London Borough of Newham

# Review of the Environmental Statement for London City Airport Final Review Report

Prepared by LUC

June 2023

**Figure 1: Hartmann Road**

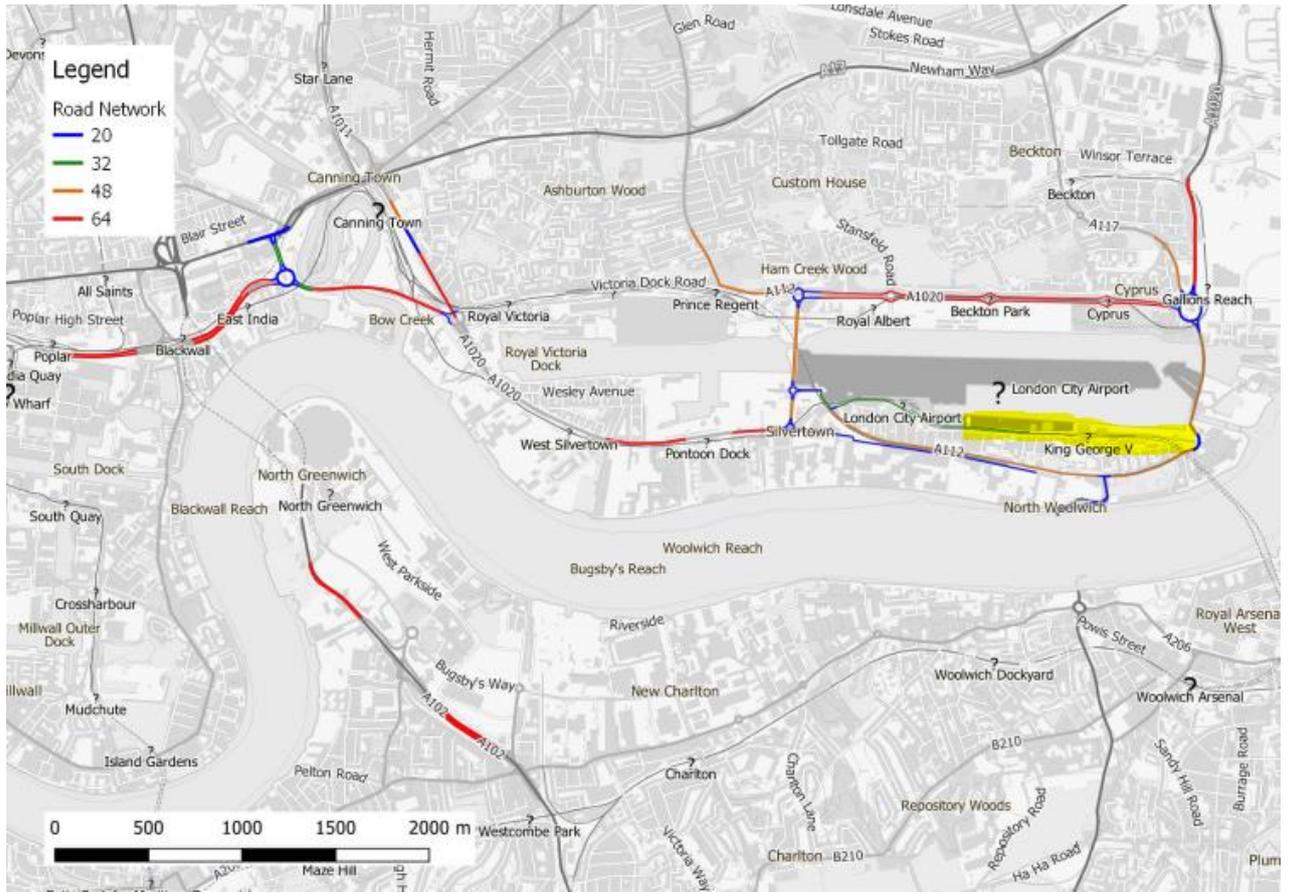
f. Figure 9.1: Modelled Road Network – I believe you modelled a new access road (committed). Can this be highlighted on the figure as I'm not sure which it is.

2.16 The eastern access link is shown highlighted in Figure 1. The eastern access to Hartmann Road (from Albert Road) is not scheduled to be opened to operational traffic until post-2030, for both the DM and DC scenarios. In the earlier years (2025, 2027 and 2029) the eastern access will be open to construction traffic only. Whilst the road link falls with the whole-borough AQMA, as previously explained it is not within or adjacent to an area where the air quality objectives are exceeded, and the construction traffic flows in the earlier years are below the EPUK/IAQM screening thresholds. As such, only the 2031 DM and DC scenarios need be considered in any detail.

2.17 The 2031 DM and DC models erroneously omitted the eastern part of Hartmann Road. Remodelling to include the extra road section increases the modelled annual mean NO<sub>2</sub> concentration by at most 0.1 µg/m<sup>3</sup> at the six receptors closest to this road. All impacts remain negligible, and the conclusions of the ES are unchanged and remain robust.

**Figure 2: Monitored versus modelled annual mean nitrogen dioxide concentrations**

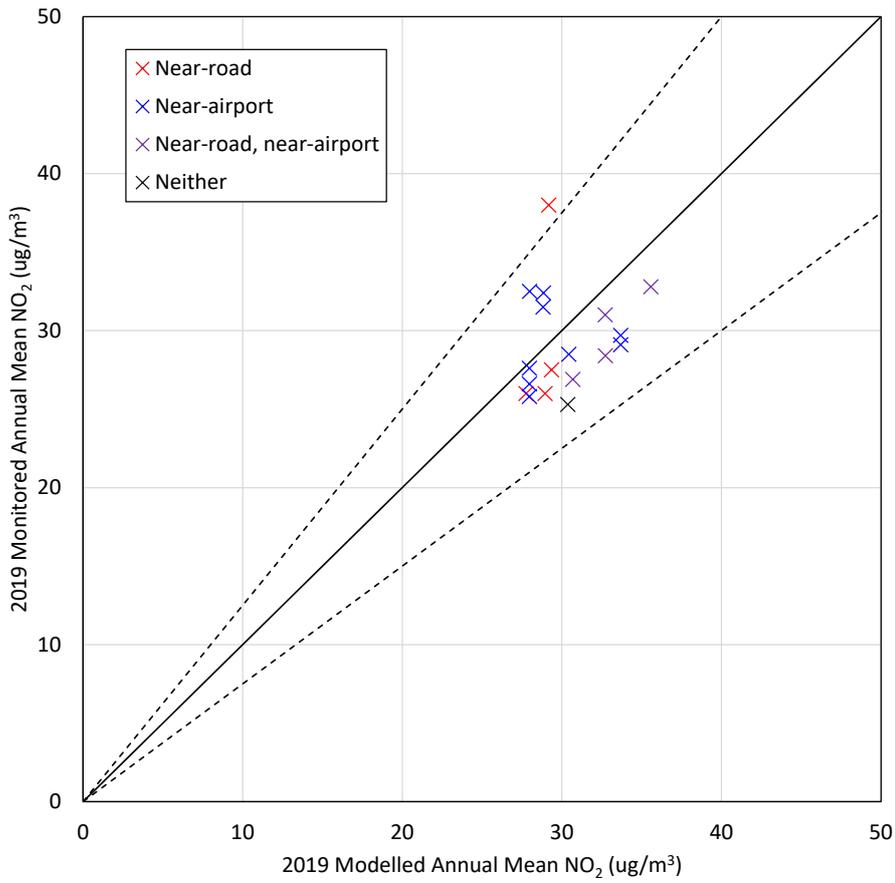
c. was analysis carried out to determine systematic vs random error? When modelling different source types it is useful to undertake a full model review. I.e. is any error applicable to all locations consistently or is it different. Uncertainty in modelling of different source types can vary. Does comparison with monitoring near to road sources and away from road sources behave in the same way?

"Figure 2: Monitored versus modelled annual mean nitrogen dioxide concentrations" Can you confirm the monitoring site ID/name for the X which is located highest visually (on the figure) which is classified as "Near-road" with values of approx. Modelled 29 and measured 38.

2.22 Figure 2 shows a comparison of modelled versus monitored annual mean NO<sub>2</sub> concentrations, as per the ES. Monitoring locations are colour-coded according to whether they are near-road (modelled road NOx contribution > 1 µg/m<sup>3</sup>), near-airport (modelled airport and miscellaneous sources contribution > 2 µg/m<sup>3</sup>; a larger value is used here since most monitors have a contribution greater than 1 µg/m<sup>3</sup>), both or neither. It can be seen that there is no apparent difference between the four groups in terms of consistent over- or under-prediction, with a slight tendency to over-predict in each case.

Figure 9: Take-off roll and climb, 09

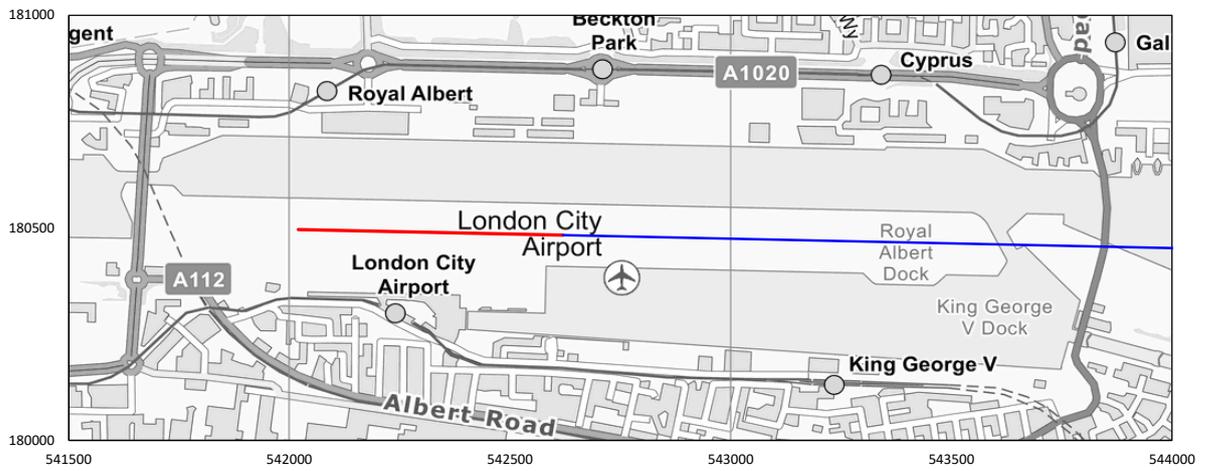
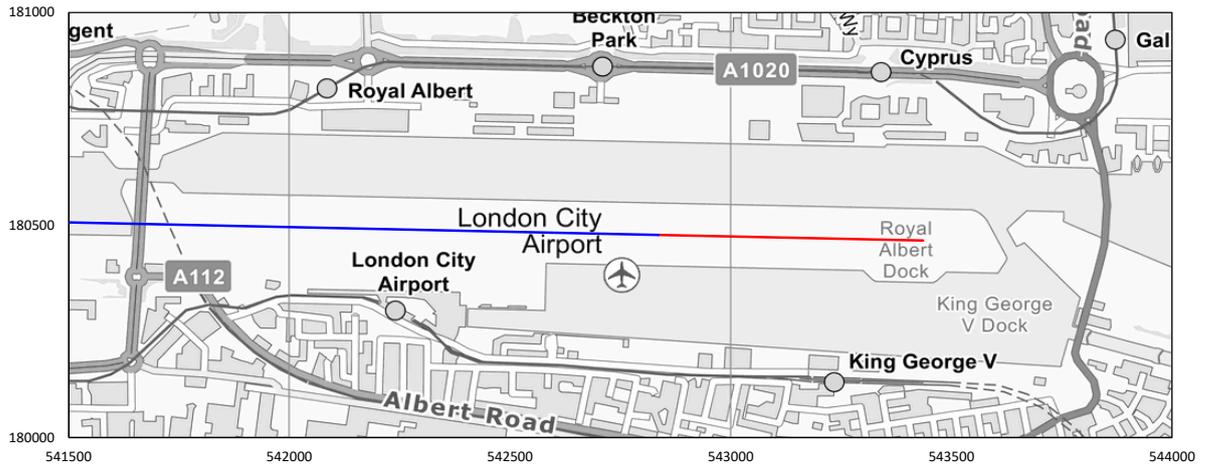
20) Figure 9.2 and 9.3. Modelled Stand Groups and Taxi Routes. It's hard to see all lines, can you confirm if there are overlapping lines? Can you provide a figure showing the take-off/climbs/approach sources. [AQ46]

Figure 13: Windrose, 2017, input to model

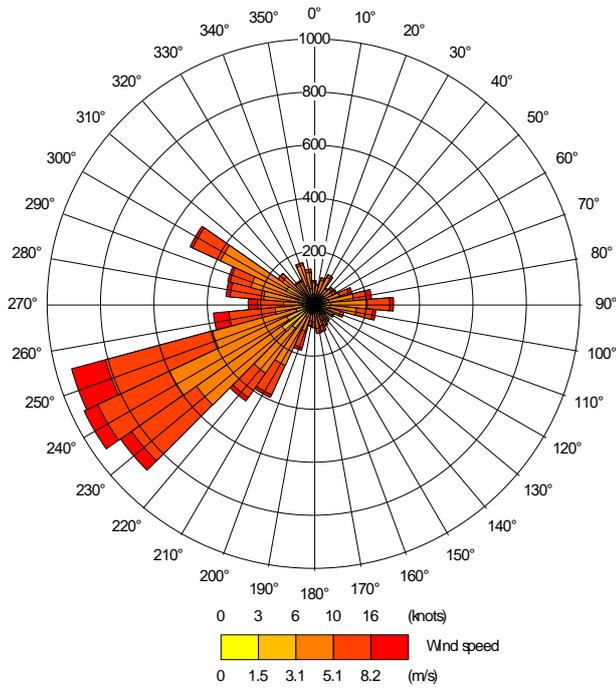
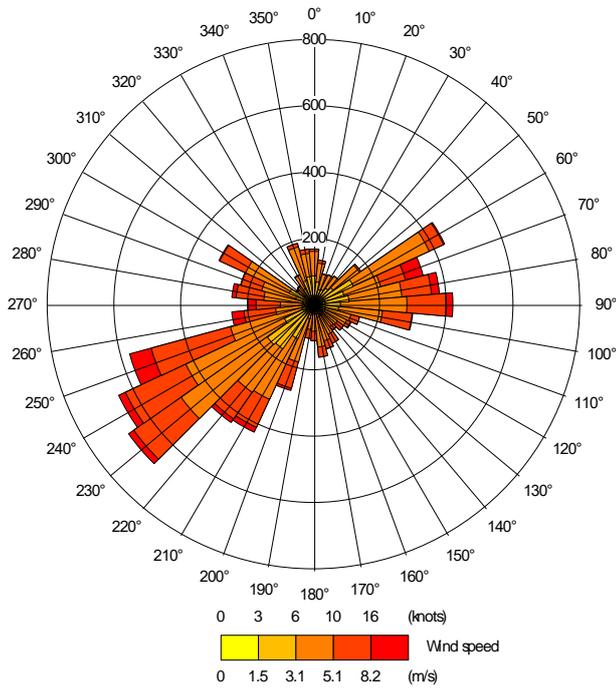
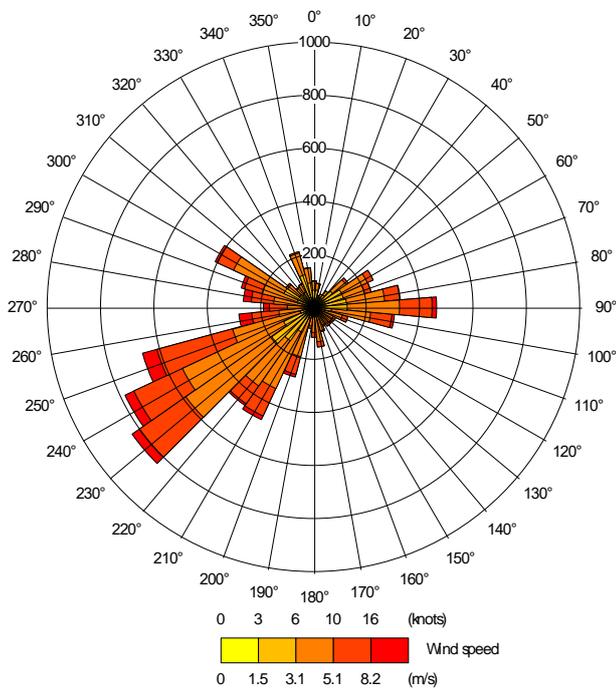
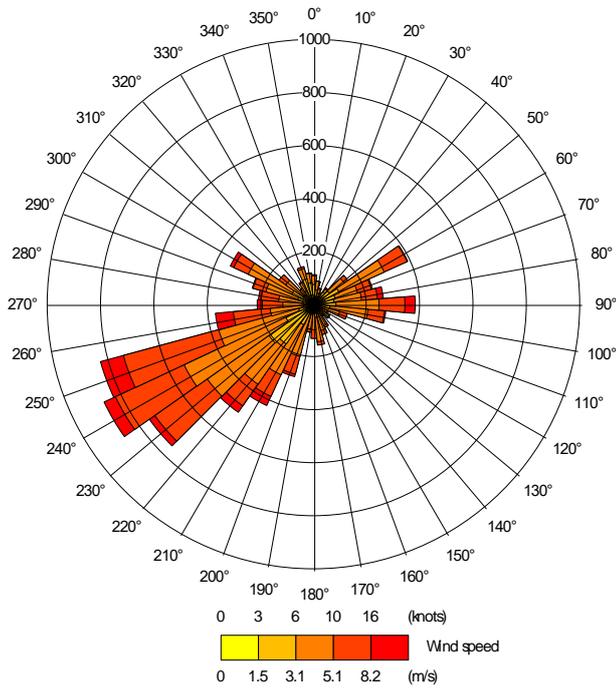
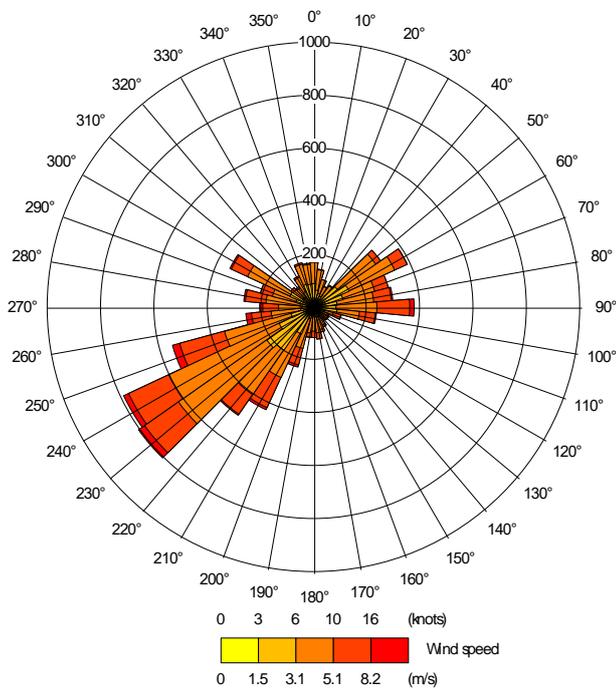
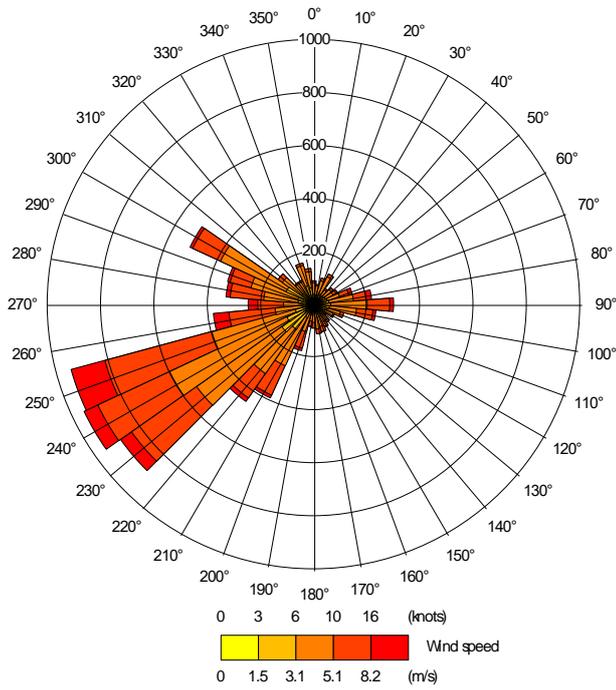
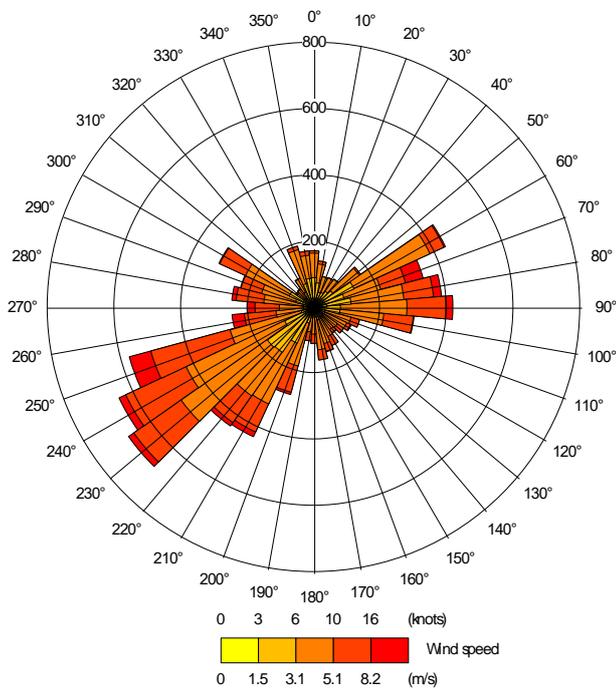
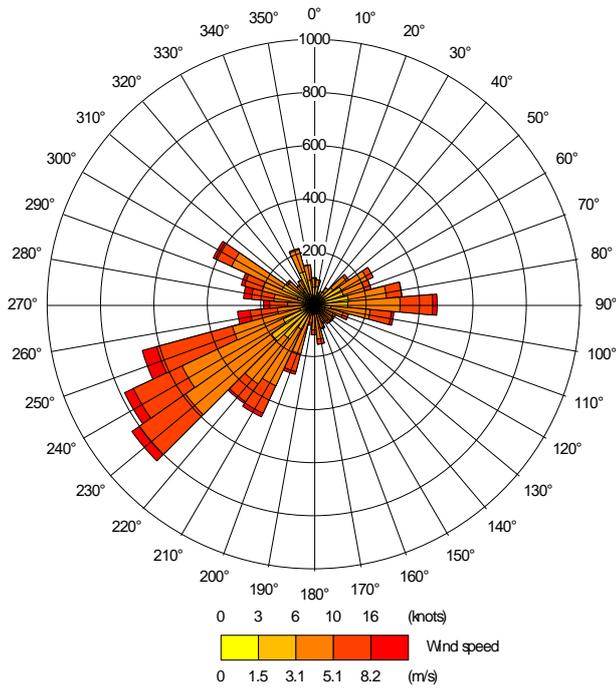
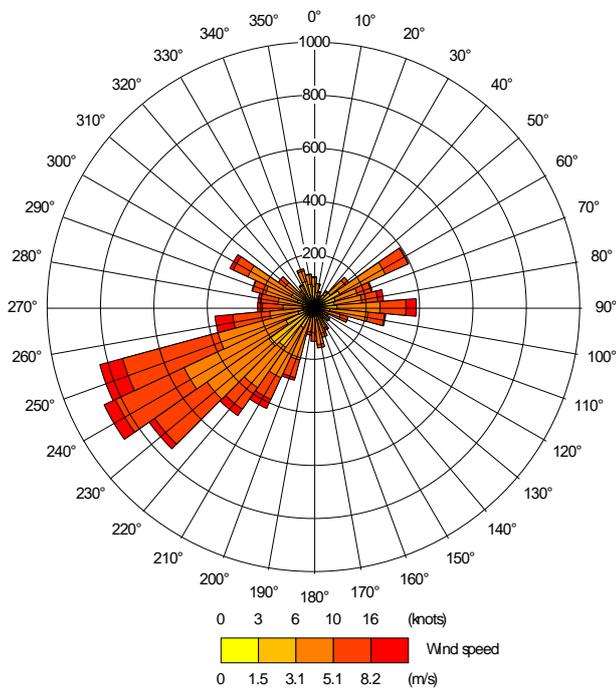
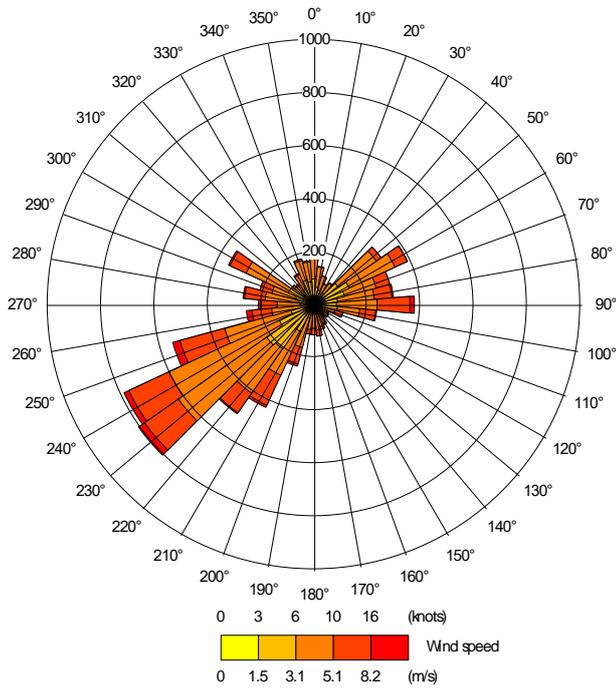
The wind roses for each year: pre-processed (input into model) and post-processed (after ADMS has run it's algorithms). [AQ47]

2.40 See figures below.
